RE: UT Docket No. 25-035-22
UCE 2nd Set Data Request (1-5)

Please find enclosed Rocky Mountain Power's Responses to UCE 2nd Set Data Requests 2.1-2.5 as well as attachment UCE 2.2.

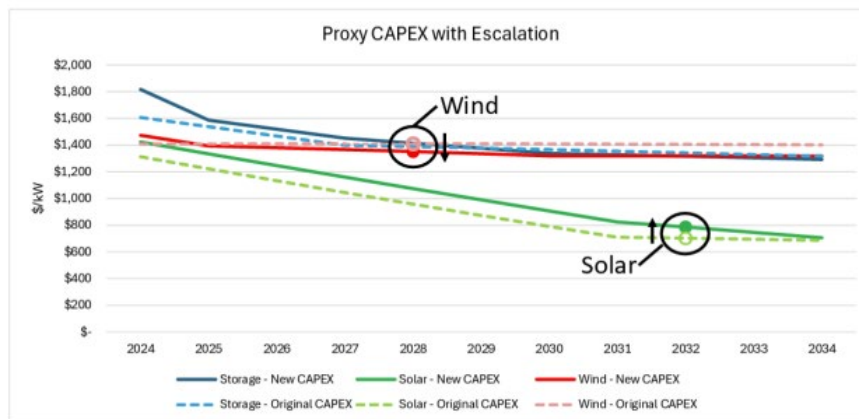
The same figure that the Company presented in the public 2025 Oregon CEP presentation was also produced in Utah Docket No. [25-035-T03 technical conference](#) on June 18th on slide 5. For clarity in this data request, here is that “Proxy CAPEX with Escalation” figure:

UCE has attempted to independently reproduce this figure but discovered that the Company's New CAPEX values still differ from the NREL ATB. UCE downloaded and reproduced the NREL ATB 2024 Data (<https://atb.nrel.gov/electricity/2024/data>) and plotted the actual NREL ATB 2024 data along with the original 2025 IRP Supply Side Resource Table (SSR Table) that the Company has identified as being erroneous. First, for example, are these two data sets for solar:

- (a) Please refer to Attachment UCE 2.2 which provides the work paper supporting the “Proxy CAPEX with Escalation” figure shown on page 1 of this data request.

- (b) PacifiCorp clarifies that the values shown in the “Proxy CAPEX with Escalation” figure shown above do not represent corrected supply-side resource table build cost inputs. In its 2025 Integrated Resource Plan (IRP) supply-side resource table, PacifiCorp calculated proxy build costs using the overnight capital costs stated in National Renewable Energy Laboratory’s (NREL) 2024 Annual Technology Baseline (ATB) and applied PacifiCorp-specific adjustments for property tax, surcharge and allowance for funds used during construction (AFUDC). The capital expenditure (CAPEX) costs stated in NREL’s 2024 ATB were not used to calculate the proxy build costs presented in PacifiCorp’s 2025 IRP supply-side resource table except for calculating the technology cost escalation rates applied to NREL’s overnight capital costs.

The “Proxy CAPEX with Escalation” figure is intended to show a correction PacifiCorp made to appropriately account for an error PacifiCorp identified in its 2025 IRP where escalation rates for each proxy resource option did not align with the earliest commercial operation year, but instead, all escalation rates began in 2025. The figure shows the impact of recalculated escalation rates on NREL CAPEX values stated on tab “Costs Forecasts”.

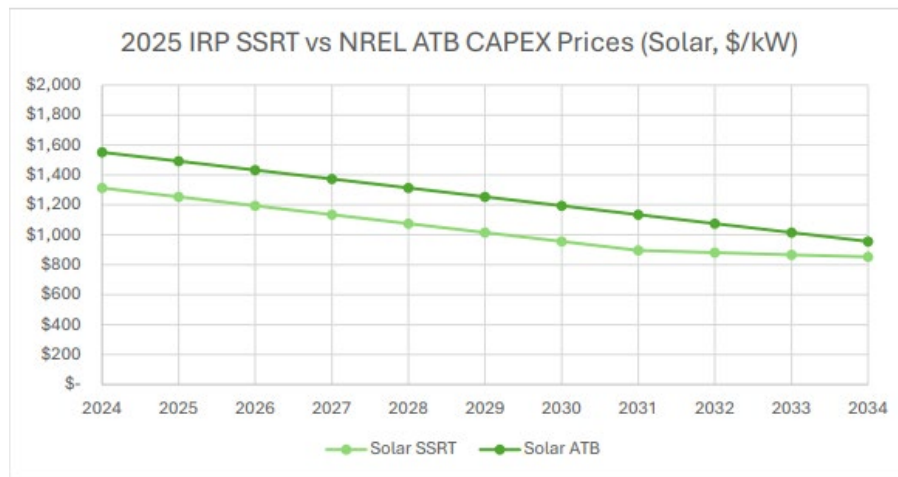
Upon close examination, the Company's "Solar – New CAPEX" data in their "Proxy CAPEX with Escalation" figure does not match the NREL ATB data. Take, for example, the resource costs in a specific year, in this case the year 2024. In the Company's updated "Proxy CAPEX with Escalation" figure for the year 2024, "Solar – New CAPEX" is approximately \$1400/kW, whereas the NREL ATB 2024 database reproduced in UCE's figure, in 2024 "Solar ATB" is \$1551.27/kW. Below is the same comparison for wind:

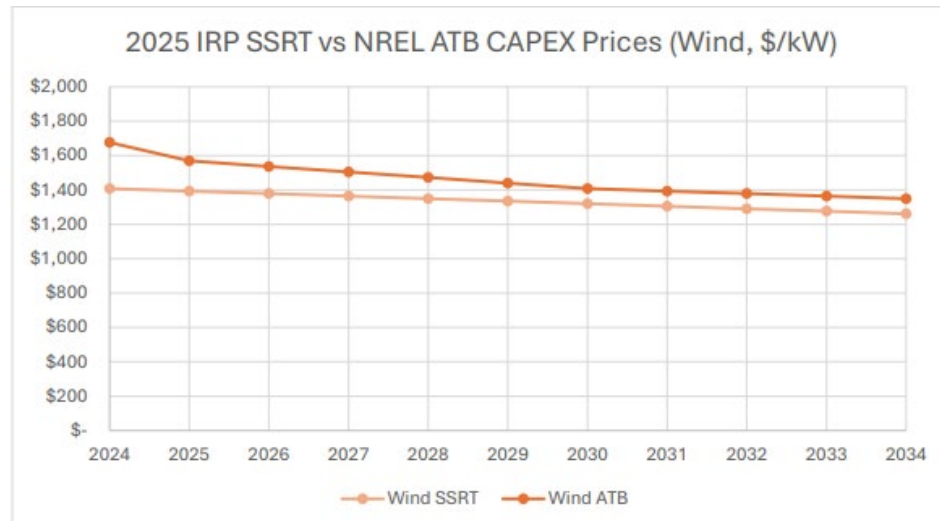
In the Company's "Proxy CAPEX with Escalation" figure for 2024 "Wind – New CAPEX" is approximately \$1500/kW, whereas the NREL ATB 2024 database shown in UCE's figure, in 2024 "Wind ATB" at \$1676.09/kW. Below is the same comparison figure for Li-Ion, 4-hour battery storage:

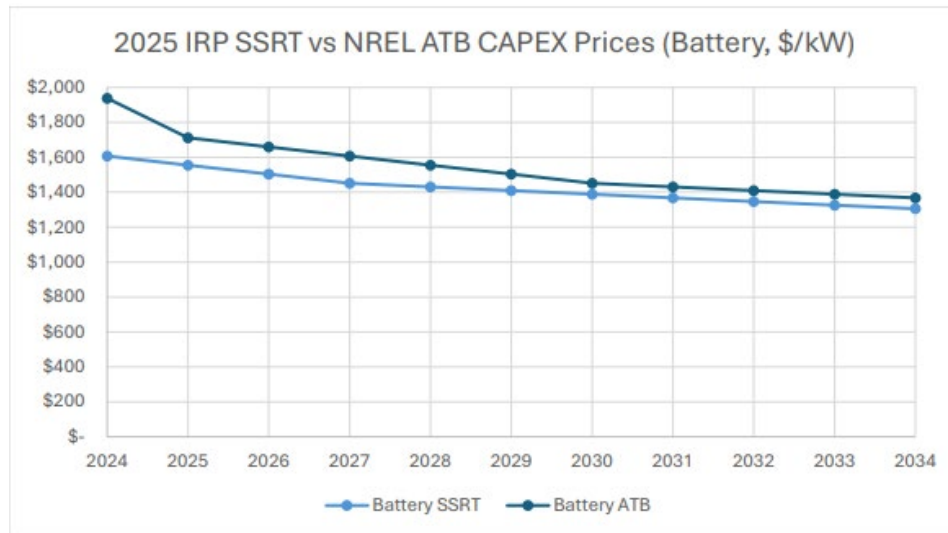
Again, in the Company’s “Proxy CAPEX with Escalation” figure in 2024 “Storage – New CAPEX” is approximately \$1800/kW, whereas the NREL ATB 2024 database shown in UCE’s figure, in 2024 “Battery ATB,” is \$1938.20/kW.
